**Coal Combustion Residue Impoundment
Round 9 - Dam Assessment Report**

Flint Creek Power Plant

Bottom Ash Dike

SWEPCO

REV	DATE	BY	DESCRIPTION	GIS	D-K	REV
1			AMERICAN ELECTRIC POWER FLINT CREEK BOTTOM ASH POND			
IDENTIFIED DEFICIENCIES						
PROJECT No		0539-0028-10		FILE No/CA Fig 3-1 of series		
DESIGN	MTS	04-20-06	SCALE 1"=20'			
GIS	AD	05-14-09	REV 0			
CHECK	WNS	06-2-09	3-1			
REVIEW

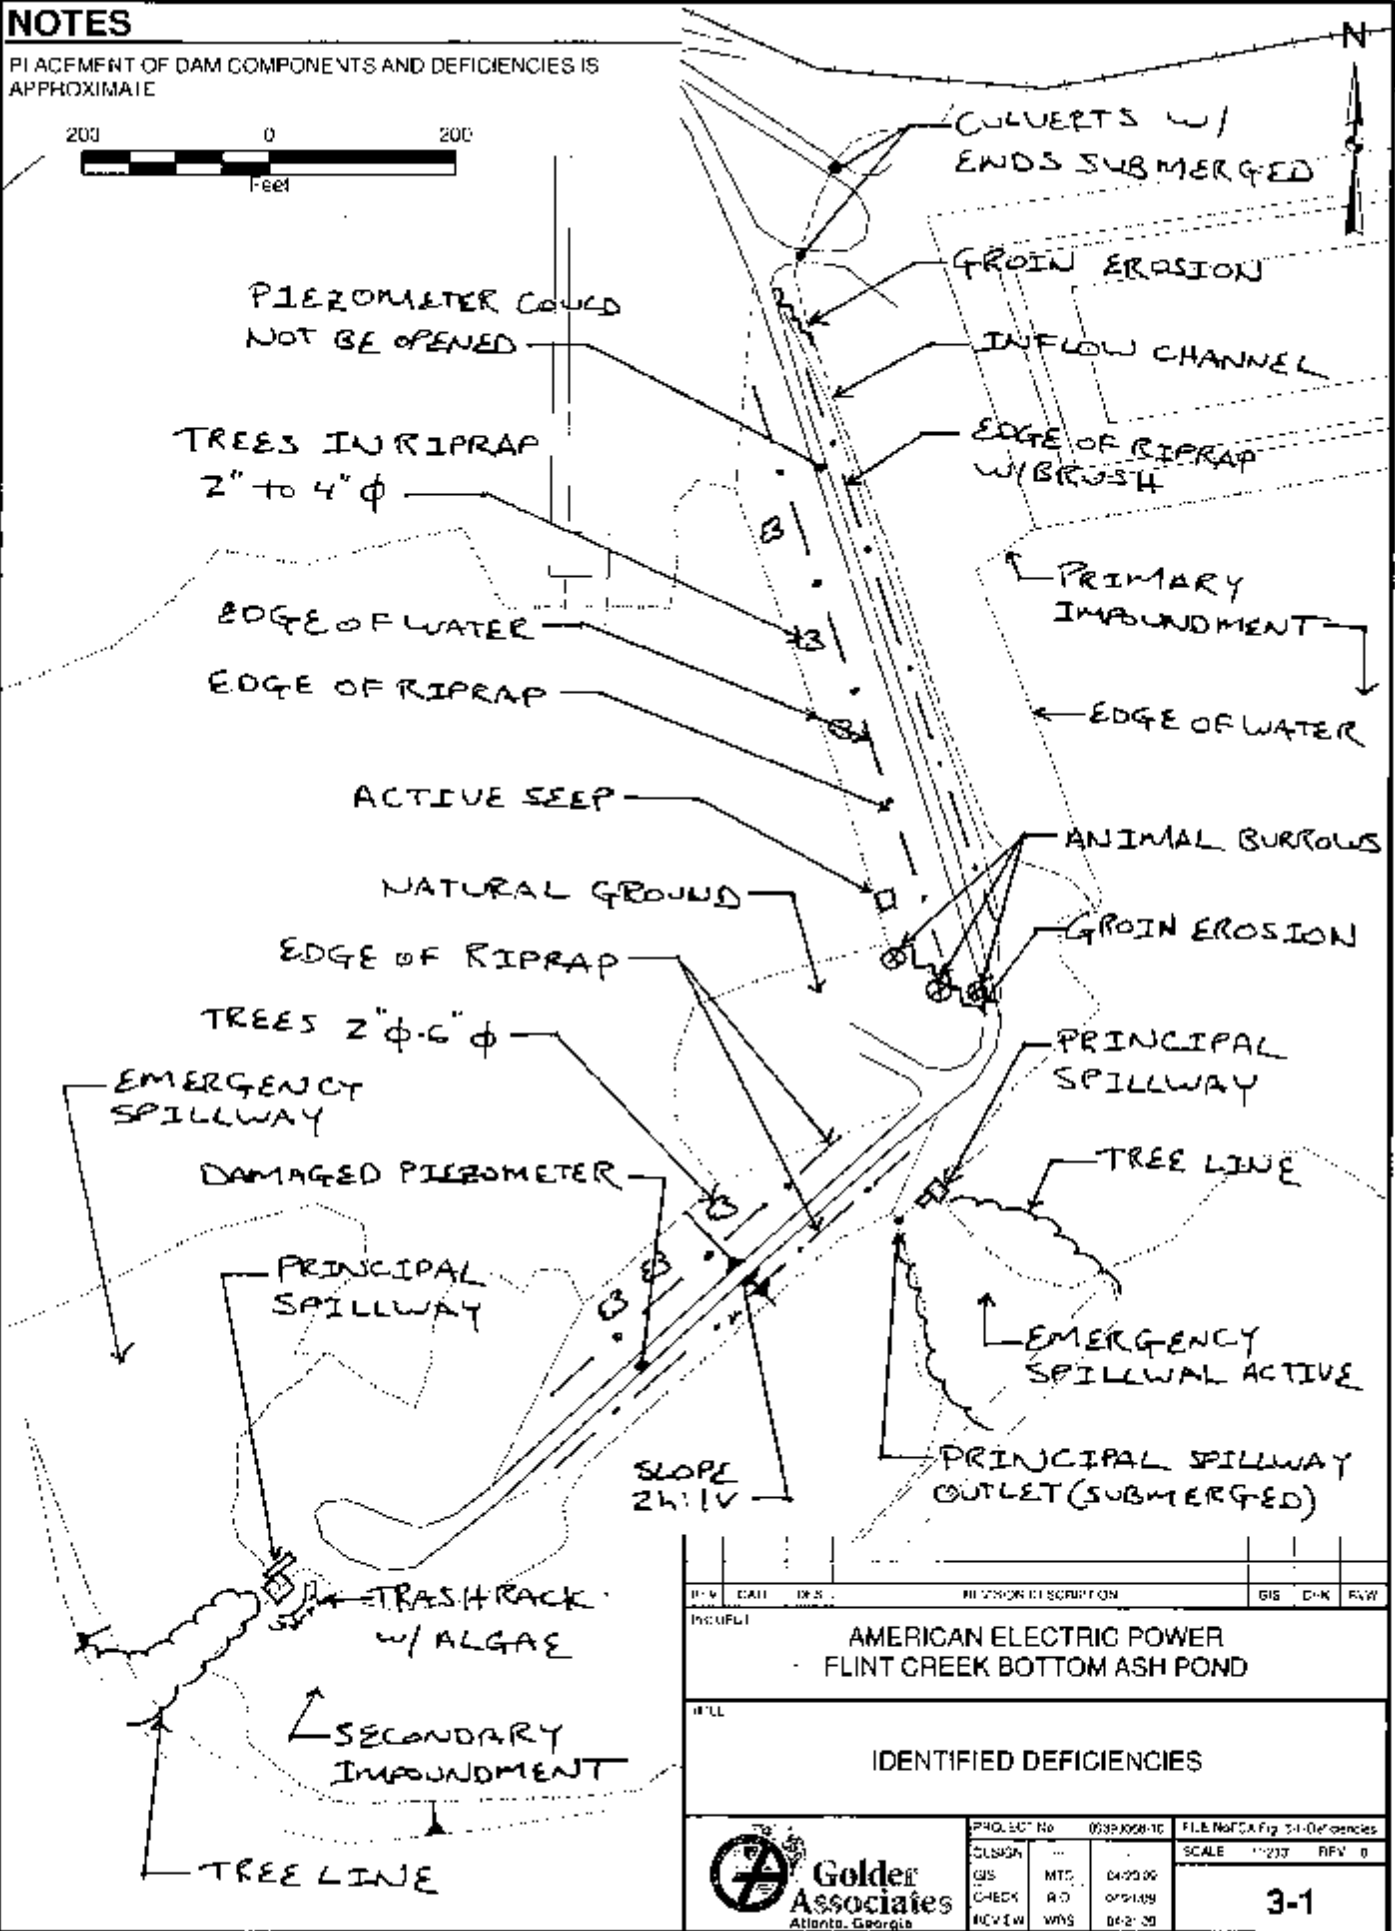
See Figure 3-1 for the location of structures and deficiencies itemized below.

5.) Emergency Spillway Channel – Primary Impoundment:
 Poor condition due to significant undesirable vegetation.

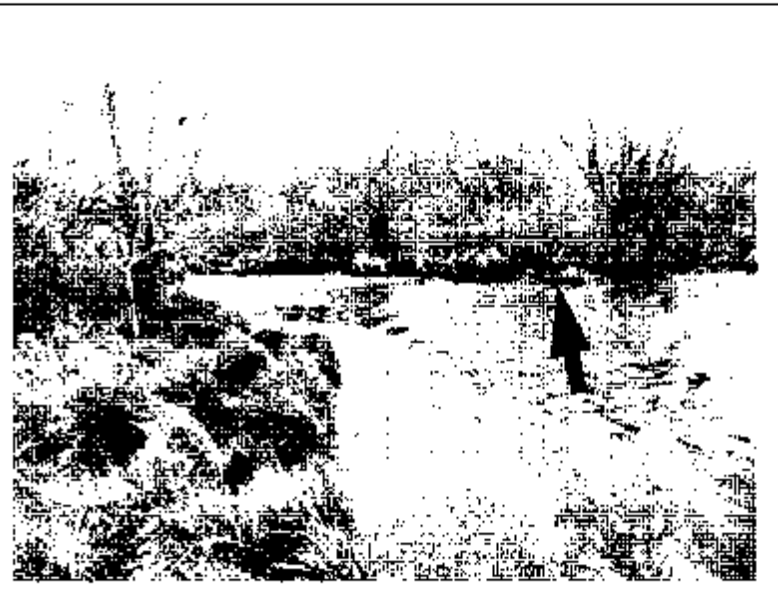
Significant undesirable vegetation obstructs channel

Photo 5. Secondary ash pond principal spillway weir with minor growth of woody vegetation and active emergency spillway prepared for reconstruction.

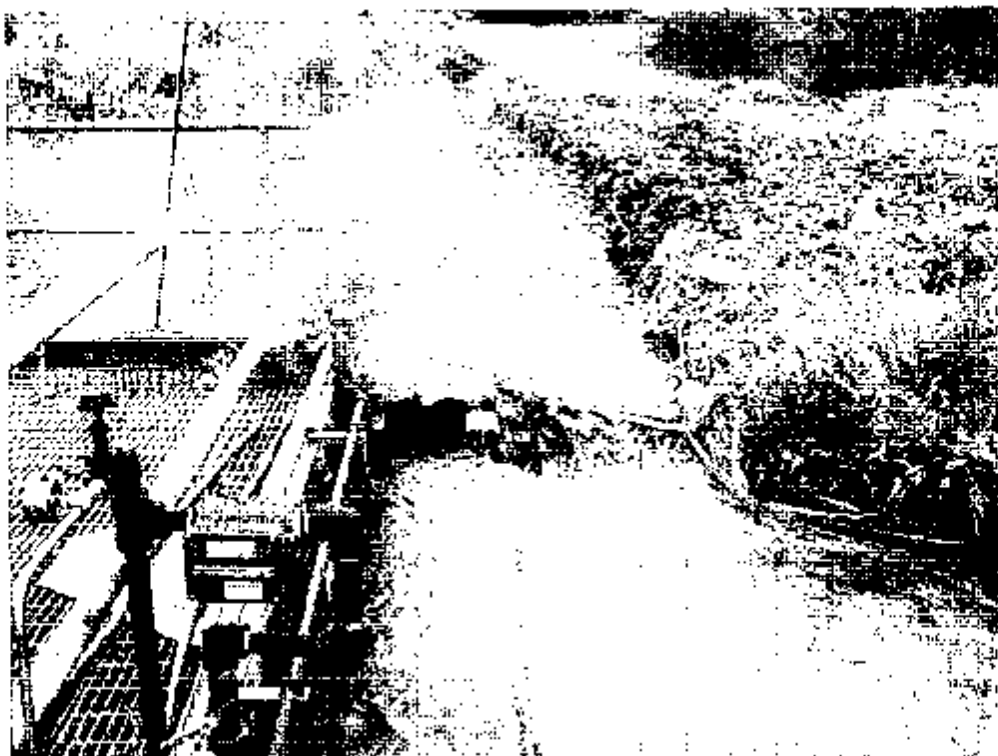
The emergency spillway at the secondary impoundment, shown in Photos 4 and 5, is an incised channel in natural ground and was active at the time of inspection. The spillway control section was designed to have a riprap-lined weir as shown on Drawings FCX-3, Sheet 1 and FCX-29, Sheet 2. The riprap lining was observed to be displaced and sporadic along the upstream side of the weir. The downstream side had been recently excavated in preparation for reconstruction activities. No signs of erosion were observed.
